AGENDA ELLETTSVILLE PLAN COMMISSION Zoom Meeting Thursday, March 4, 2021 - 6:00 P.M.

PC 21-06 – Preliminary Plat Staff Report

PC 21-07- Preliminary/Final Plat Staff Report

PC 21-02 – Preliminary Plat Staff Report

Summary

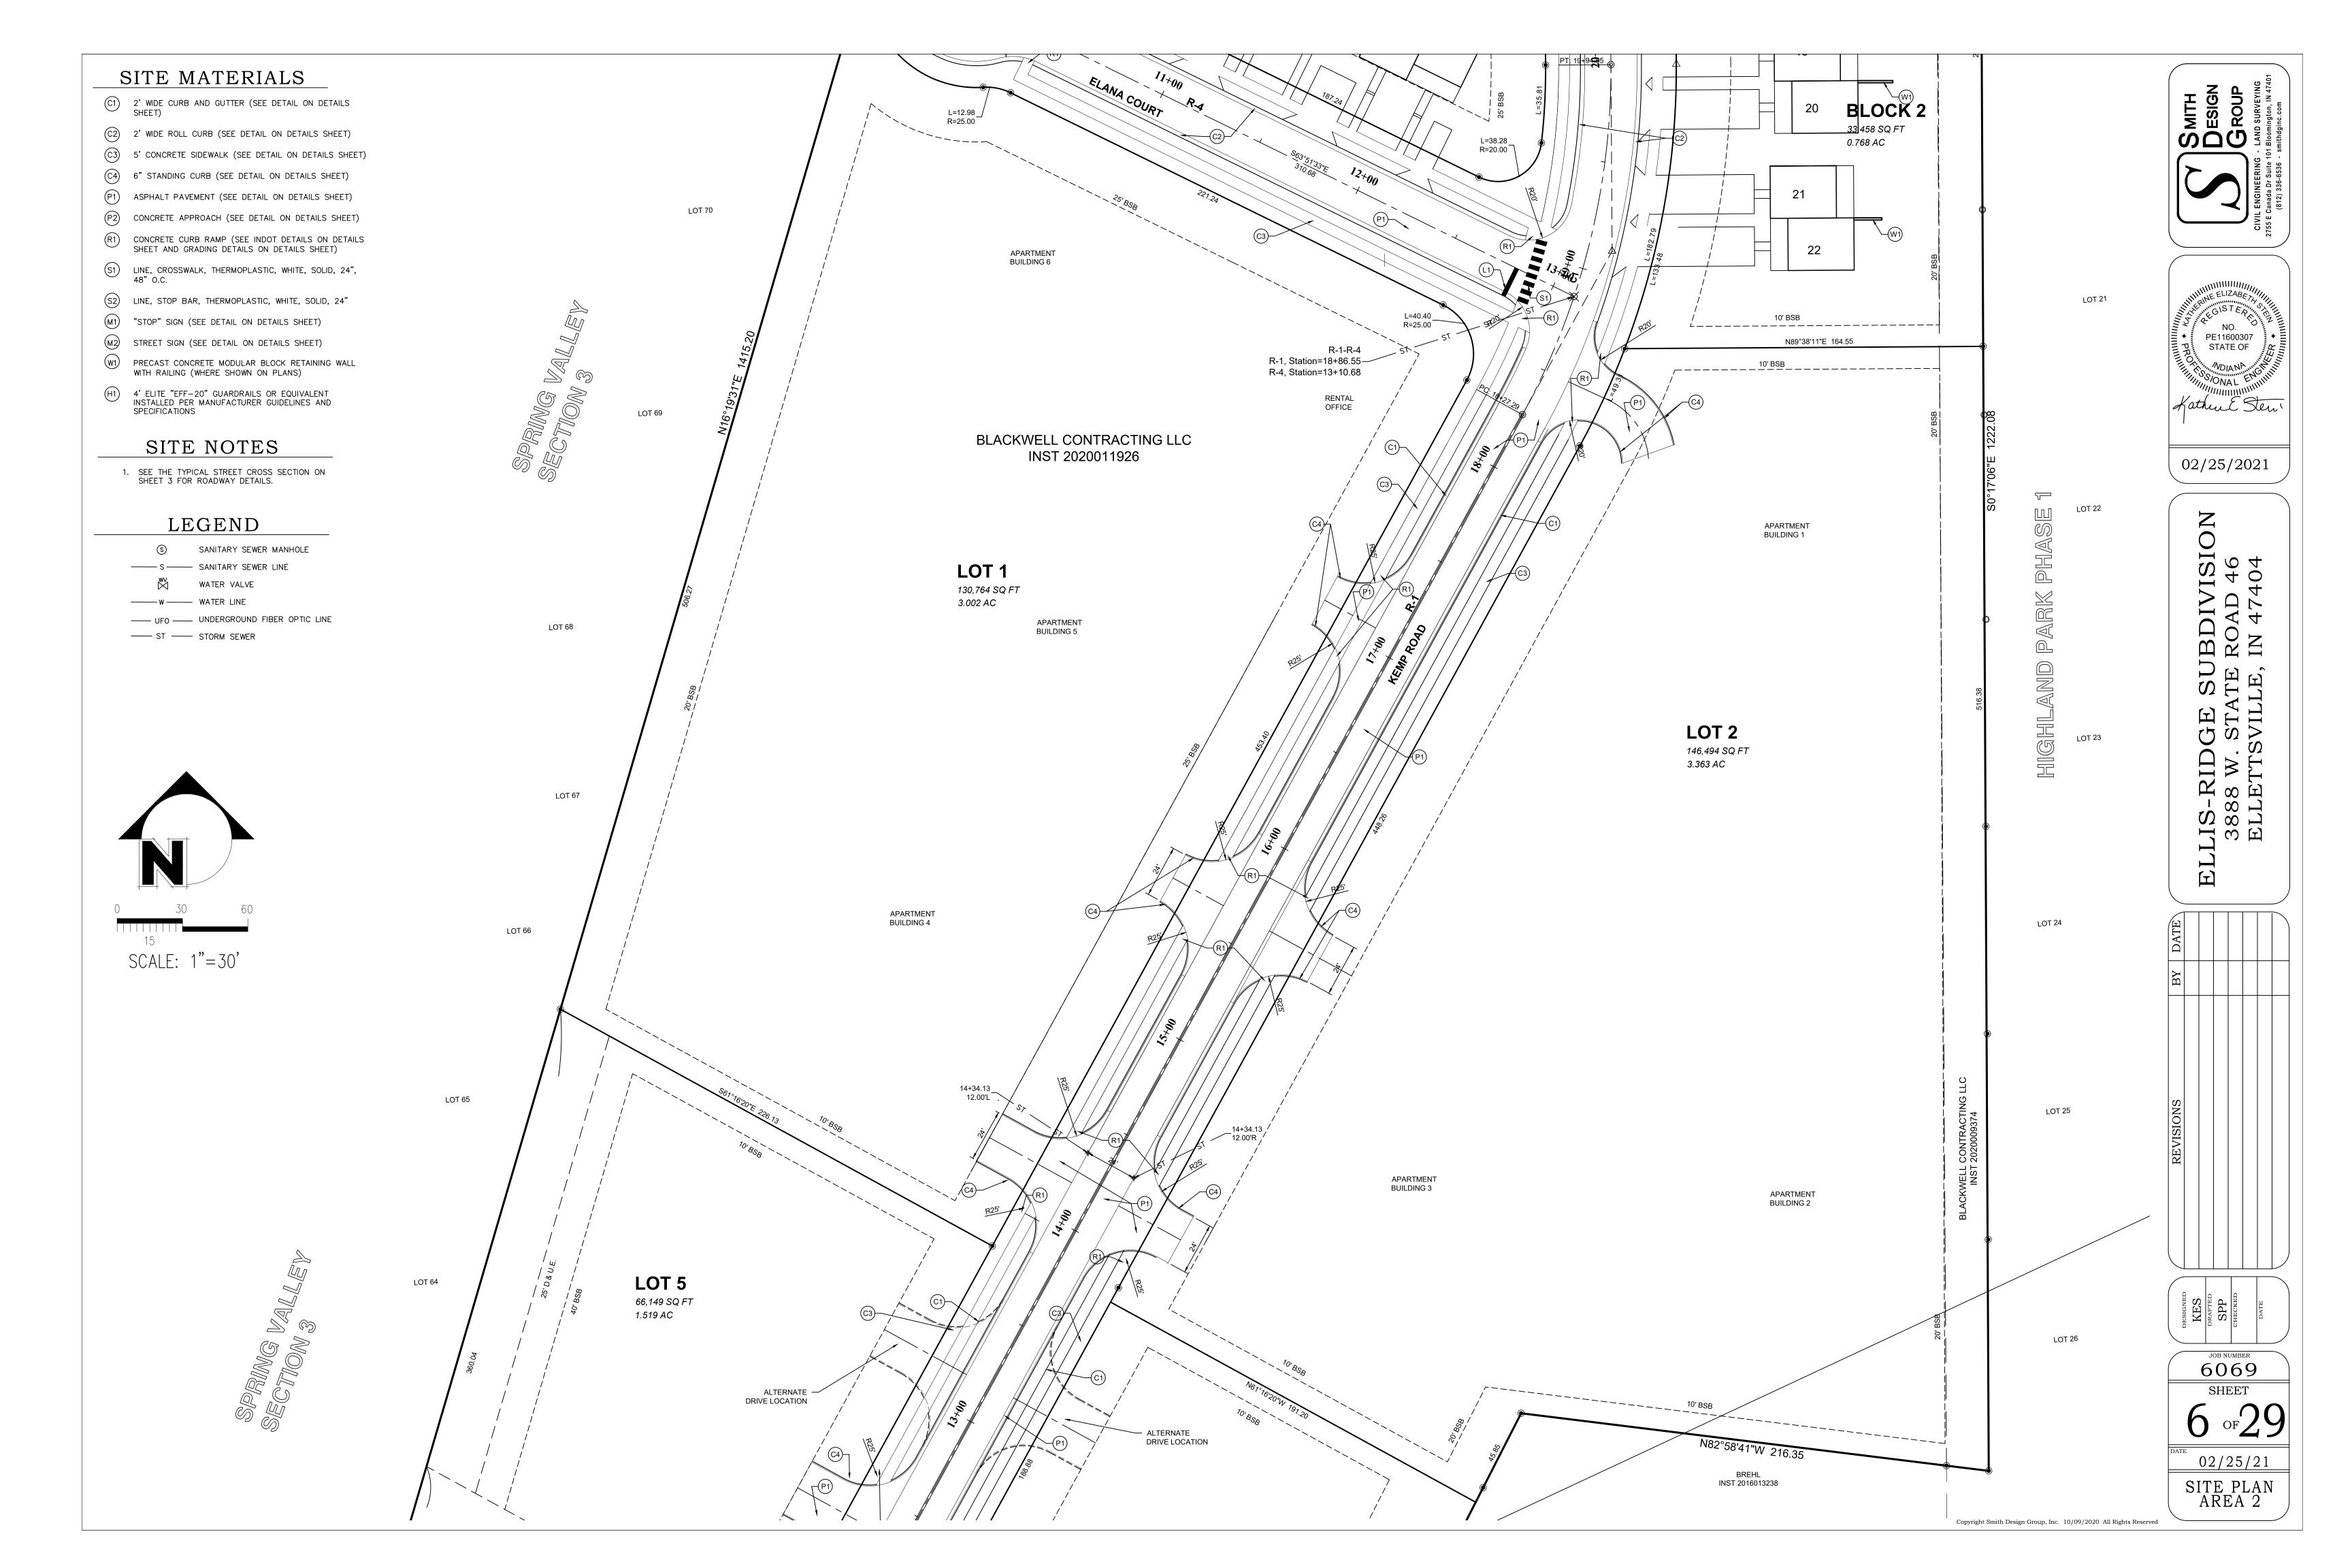
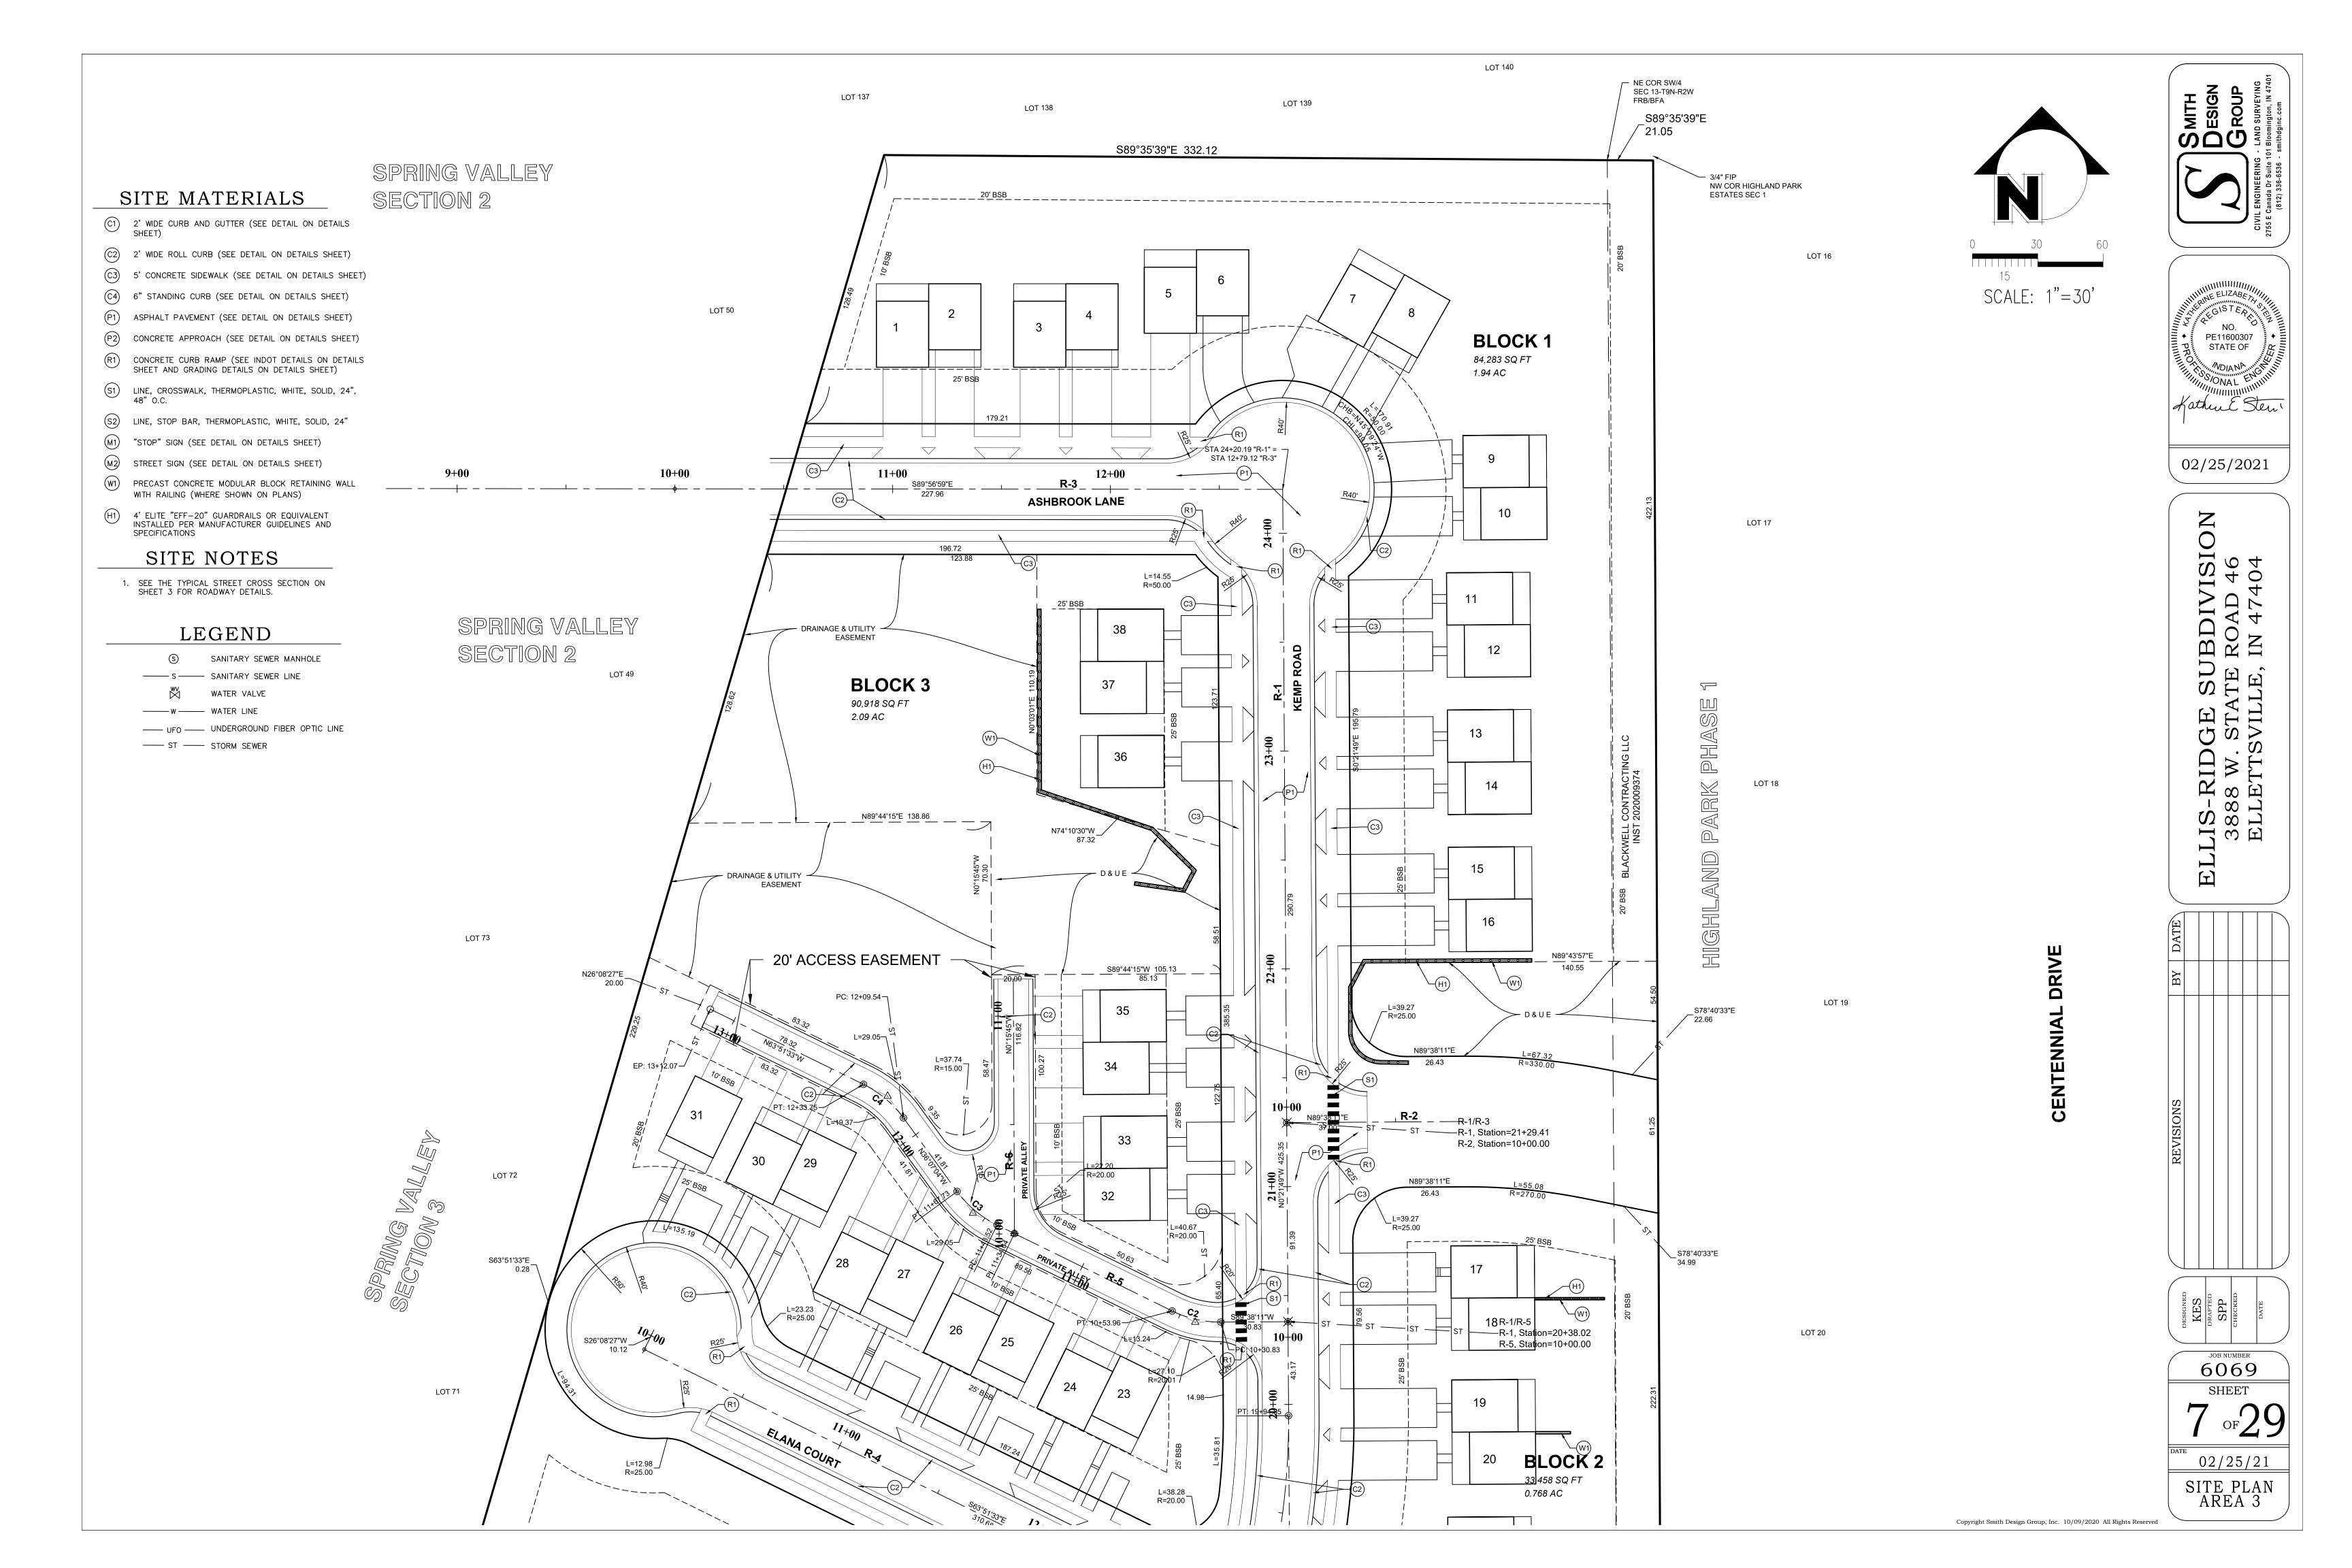
1. A landscape plan will need to reviewed prior to the Plan Commission meeting.

- 2. Street names will need to be provided for the cul-de-sac and the road connecting Ashbrook and SR 46.
 - a. Ellis Court cannot be used as there is already an Ellis Road in Monroe County.
- 3. All paired patio homes shall have a minimum of four (4) dedicated parking spaces.
 - a. This includes any spaces in a garage, driveway, or other dedicated off-street parking.
- 4. Alleys should remain as private roads.
- 5. Final plans shall be stamped by engineer.

- 1. Tracer wire should be used on all newly installed lines.
- 2. On page 24, the street sign detail shows in accordance with the City of Bloomington. Please change that to Town of Ellettsville (Town Ordinance 153.086)

- 1. Typical sections show the sidewalk dimension as 5 feet but there is a note referring to 4 feet.
- 2. An INDOT driveway permit will be required.
- 3. Setbacks should double when the commercial sections are adjacent to the residential zoning. The rear yard setback would be increased to 40 feet instead of the 25 feet as shown. (152.190)

- 4. The GIS aerial photography shows a pond on the property. The existing contours and development plan do not indicate a pond on the property. Removal of the pond should be approved by the appropriate governmental agencies.

- 7. Please provide detail of the retaining walls.
- 8. The detention pond underdrains should be shown on the grading and drainage plans.
- 9. The sanitary sewer will be reviewed by the Eastern Richland Sewer Corporation.

- 10. Drainage calculations will need to be submitted. The detention pond in the southwest corner of the property is shown connecting to and existing structure from the Springs Valley subdivision. The existing structure has a 12-inch pipe and Str. 101 has an 18-inch outlet pipe connecting to that structure. In addition, the depth of the existing structure does not seem to be adequate to connect to Str. 101.
